# 3801 Stone Way N.

*Design Review Recommendation*

08/19/2013

DPD #3014111

Elevation: East  
3/32" = 1'-0"

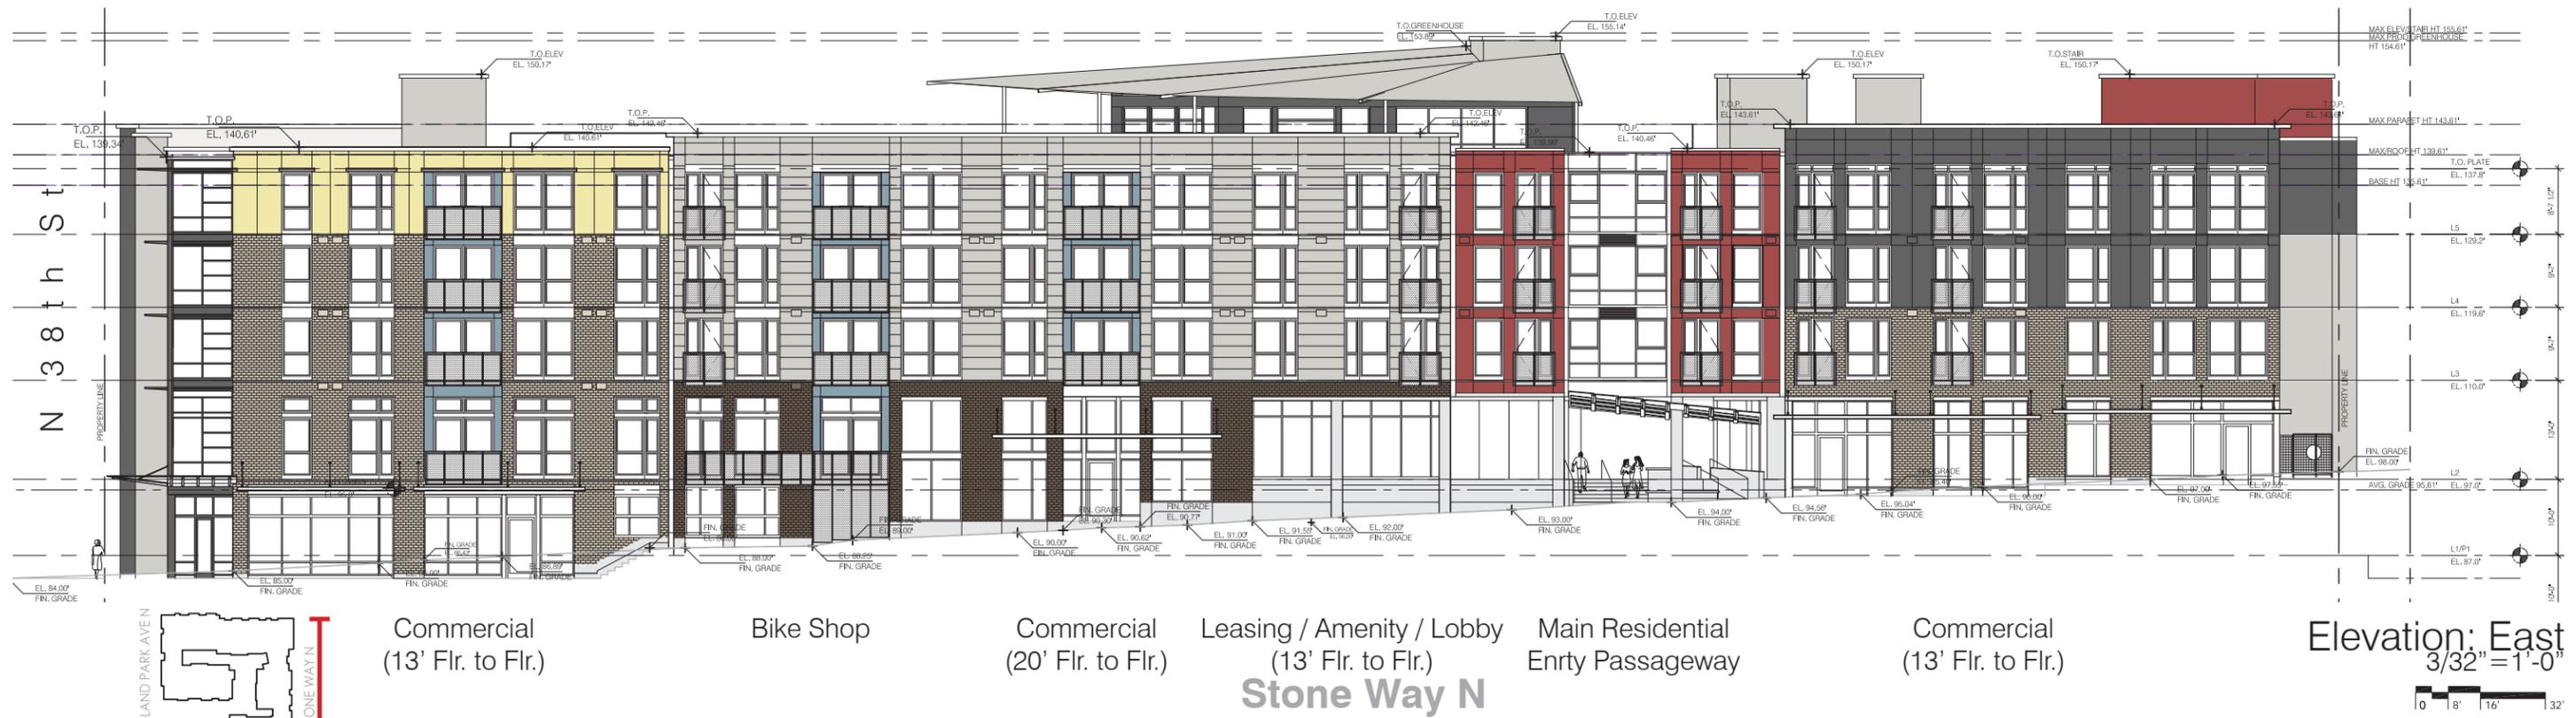
*DPD Correction #1: East Elevation. The step down of the parapets appears too meager to meet the board's intent for the building to step down the hillside. The roof is for the most part one continuous plane. Eliminating the glass screen at the parapet in the recessed portion of the façade would be a modest start*

*Roof line – The design team has used parapets and façade modulation to vary the building height. Each "building" of the overall façade uses setbacks from the property line to differentiate masses, which also helps to break-up the horizontal plane of the roof line. Additionally, the design team has used parapets of various heights to break-up the horizontal plane of the roof line and also help designate differing building masses.*

*The project's design through façade break-up and treatment, street level relationships, and stepping at the roof line reinforces the sense that the project is stepping down the hill with the site's slope. This design response is carried through on all three street facades. We have also recognized, and celebrated the intersection at Stone Way and N. 38th with unique corner façade treatment and increased setbacks.*

## Design Response

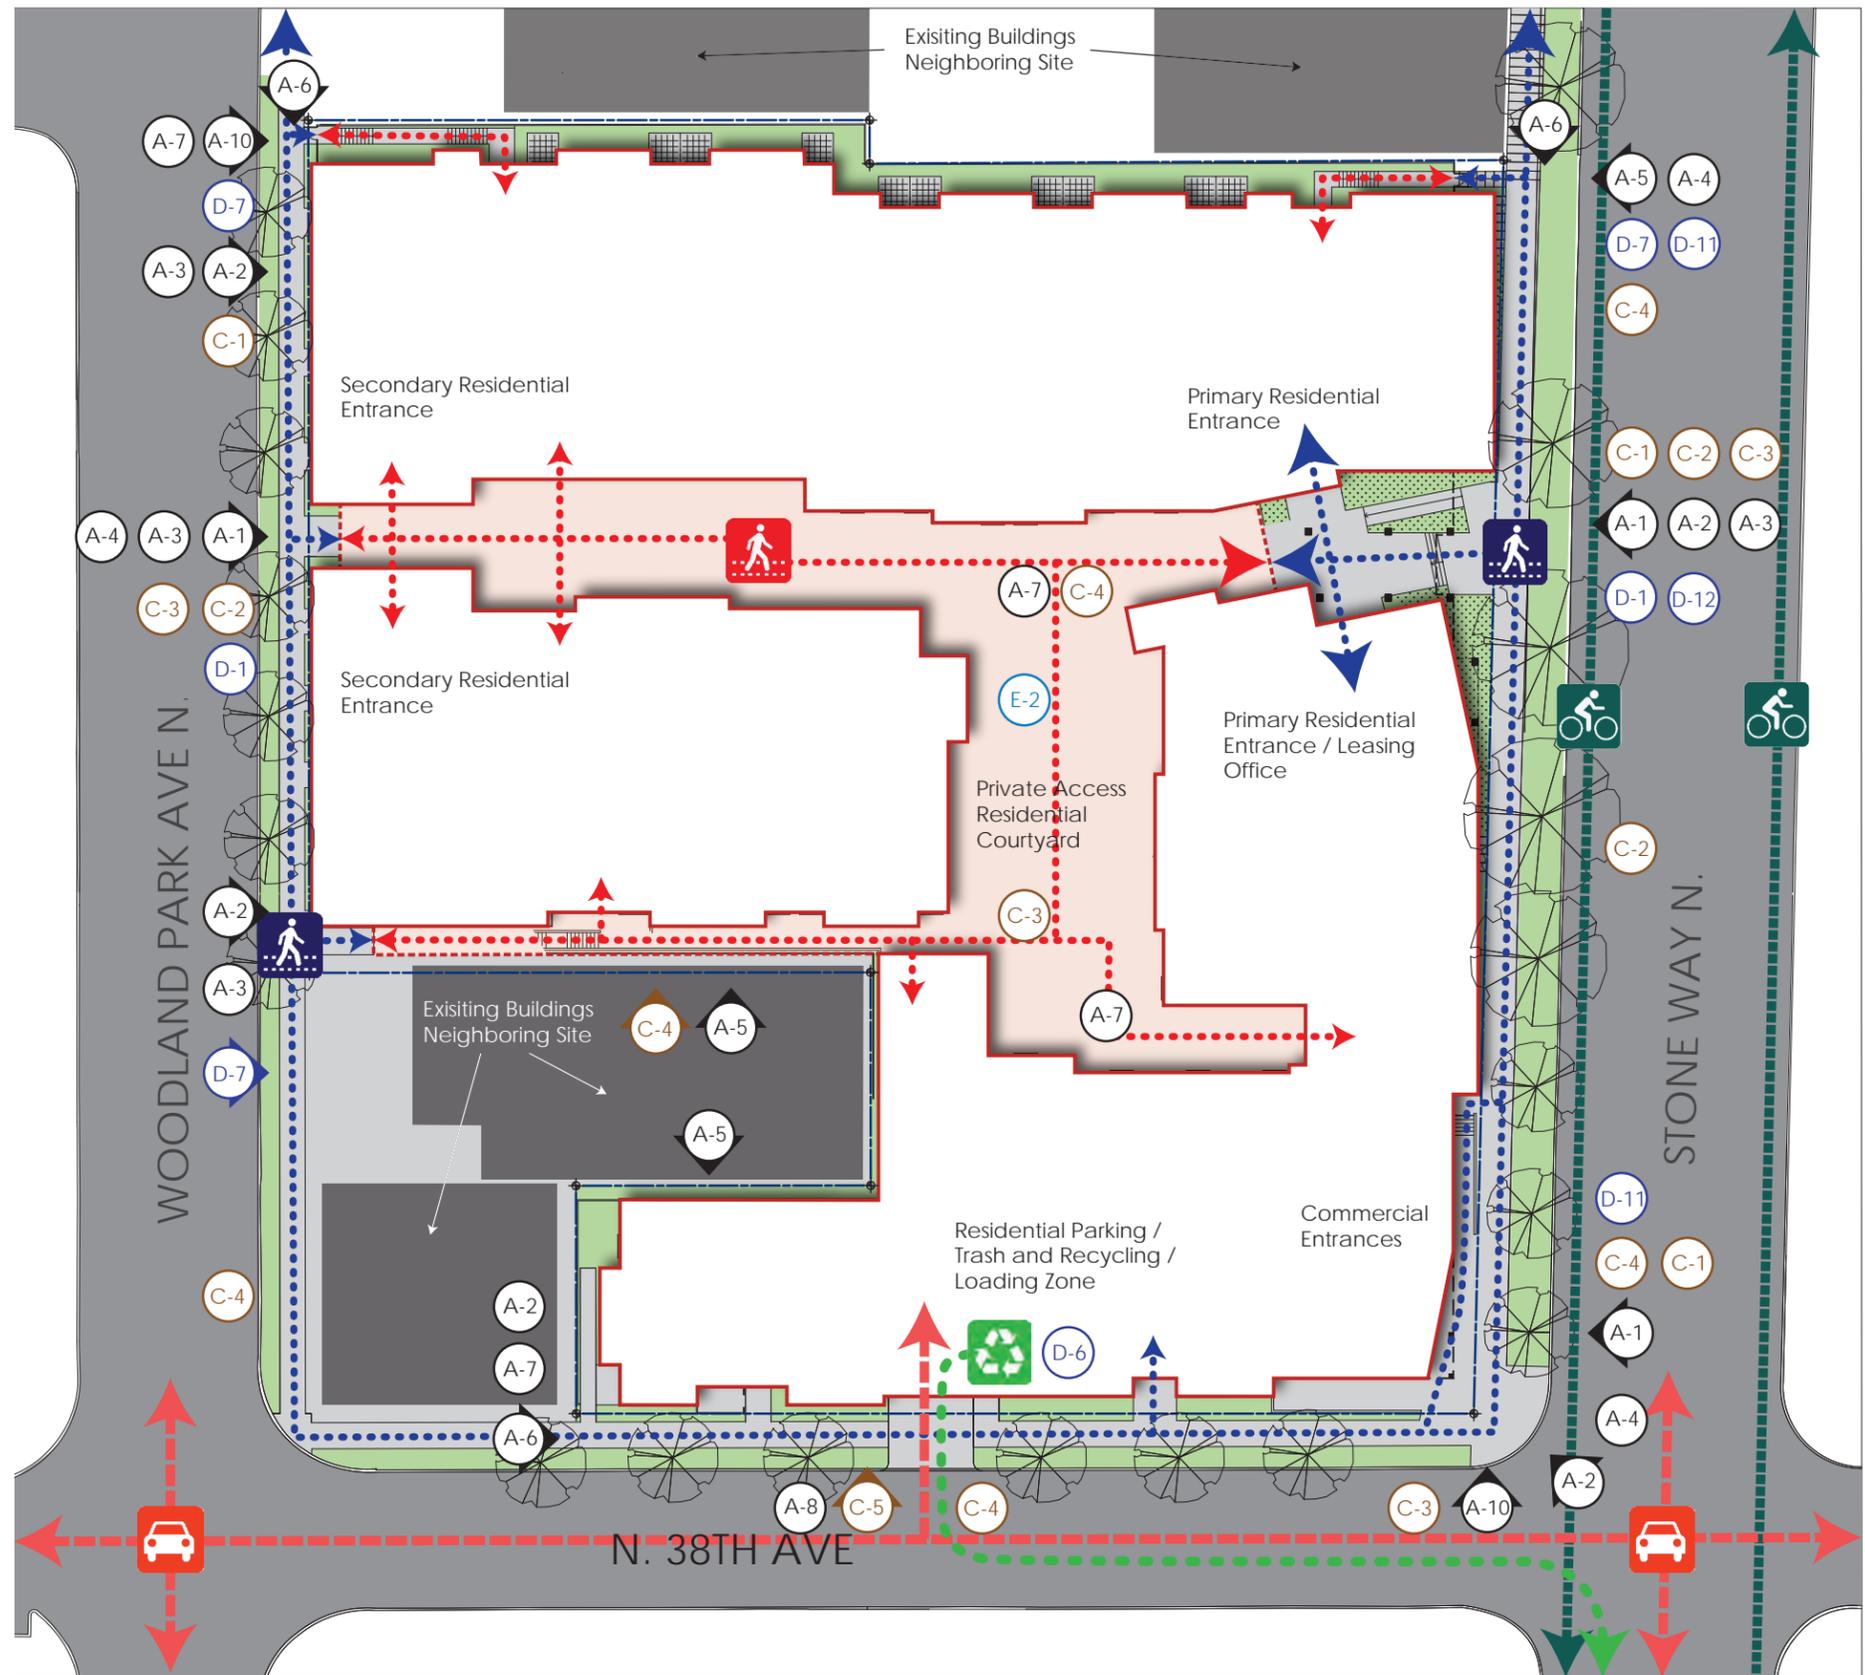
1. **MASSING:** Recommended considering breaking up the massing along Stone Way N. into at least three distinct façade elements
2. **SITE:** Building should respond to site's topography

8. **MAIN RESIDENTIAL ENTRY:** Recommended moving the original main residential breezeway entry to a spot about 1/3rd down the block on Stone Way N.

1. **MASSING:** Building broken up along Stone Way into three main elements with additional facade differentiation, and a deep inset break, at the main residential entry breezeway; similar parti at Woodland Park Ave. N. and N. 38th St.

2. **SITE:** Building massing, roof parapets, and building entries step down in response to site topography on all three streets.
3. **COMMERCIAL FRONTAGE:** Commercial Storefronts are provided at these designated locations. Five commercial spaces step down Stone Way N.; all spaces have entries at sidewalk grade; Live-Work units are provided along 50% of the Woodland Park Ave. frontage.

6. **CORNERS:** The building facades at the Southeast and Northwest corners have been designed in response to their special locations, and are distinguishable within the overall parti.

## Exterior Lighting

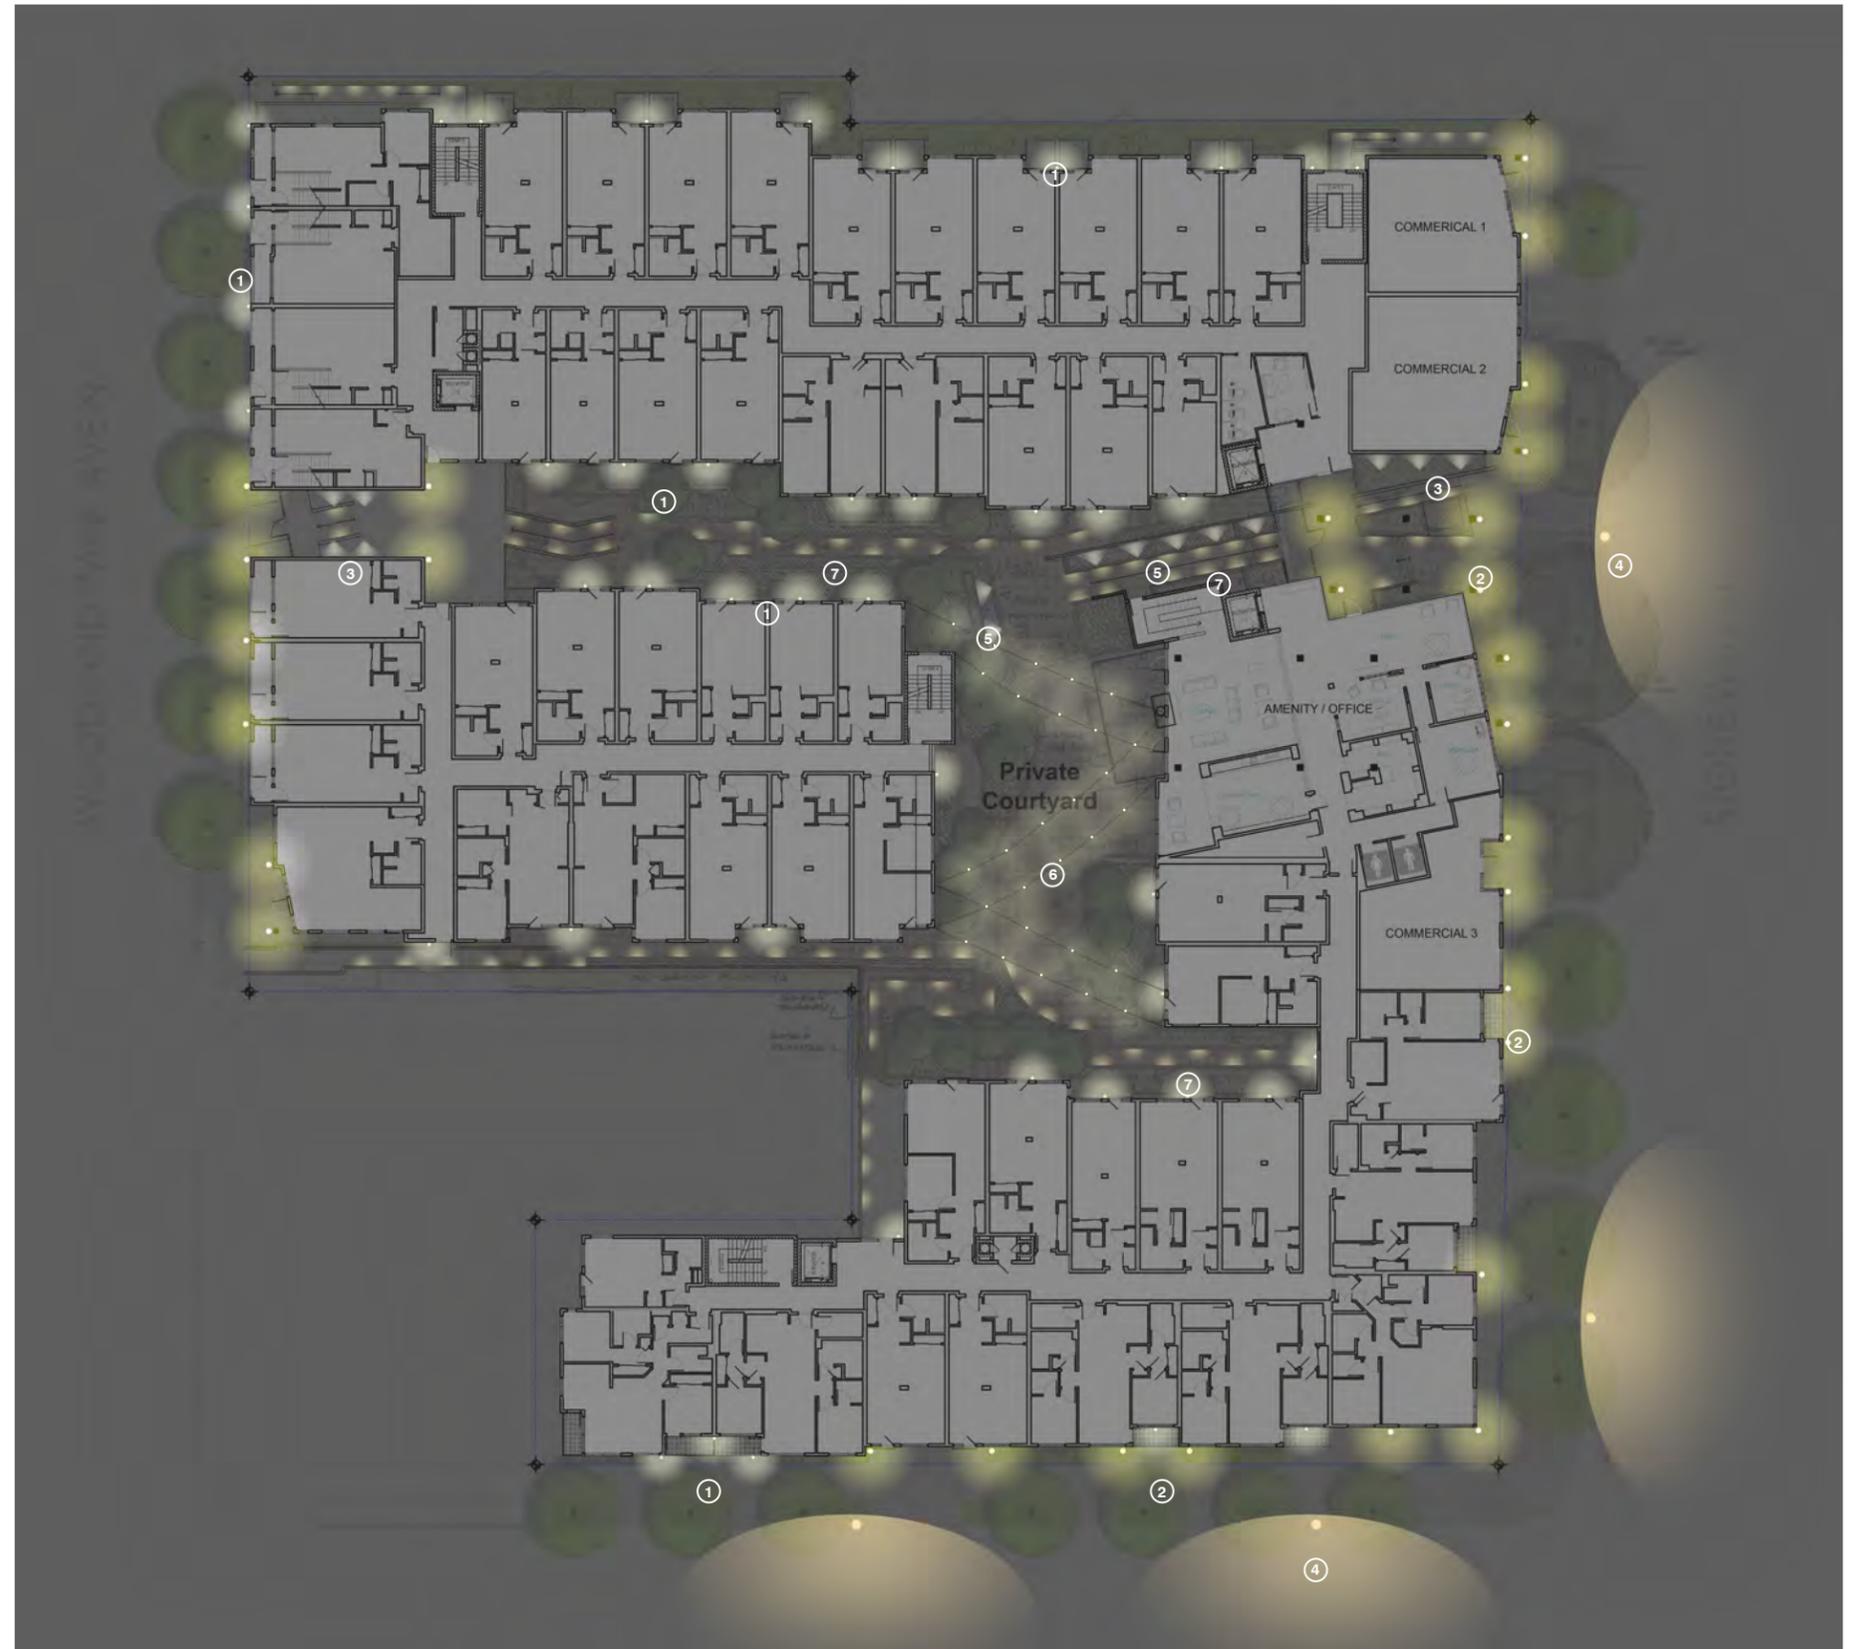
*EDG Meeting #2: Provide a concept lighting plan at the Recommendation meeting.*

1. Small Decorative CFL Sconces (Residential)
2. Large Decorative CFL Sconces (Commercial)
3. Canopy mounted down lighting
4. Existing Street lighting
5. Planter up lighting
6. Festival Rope Lighting
7. Concealed bench lighting
